Sent: 20/04/2020 10:33:53 AM
Subject: 41 Upper Clifford Avenue, Fairlight
Attachments: Objection letter - 41 Upper Clifford Avenue, Fairlight.pdf;

41 Upper Clifford Avenue, Fairlight
Development Application No. 2020/0302
Demolition works and construction of multi dwelling housing

Figure 1. Photograph from primary living room window

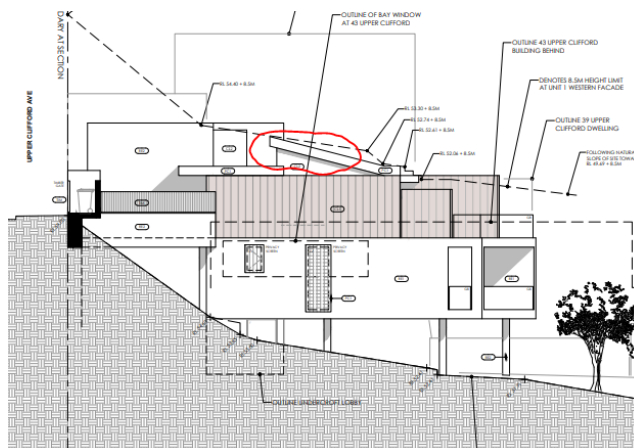
Views achieved from the key living area of 1 Ashley of high value. They include the harbour, the land and water interface and the heads. The views are from the key indoor living spaces of the premises. When considered under the principles of Tenacity Consulting Pty Ltd V Warringah Council (2004) NSWLEC 140, the views would be considered high value.

The views are available from the living area on the ground floor and secondarily through the bedroom on the first floor. See photograph below.

The impact of the loss will be significant for this property and no analysis of the view loss appears to be included in the Development Application. We note that the view available to this property has decreased over the years with properties on either side of 41 Upper Clifford Avenue, and no 46 Upper Clifford Avenue developing under previous planning schemes. The owners have provided copies of photographs showing the reducing views that have occurred over the time period since they purchased the property in 1993. The remaining view corridor is invaluable to the amenity of the property and could be easily retained with an alternate design approach.

The views are over the front of the property and enjoyed from both a sitting and standing position. A standing view is provided in the photograph above. It is considered a realistic expectation that this view could be maintained.

The key view loss of concern is from the principal living area and great significance should be placed on these views as they form part of the key amenity and value for the dwelling. It appears that the land/ water interface view will be lost, but inadequate detail is provided to adequately determine the exact view loss. More information is required from the applicant and we suggest that height poles are essential to allow for a view analysis to be completed.
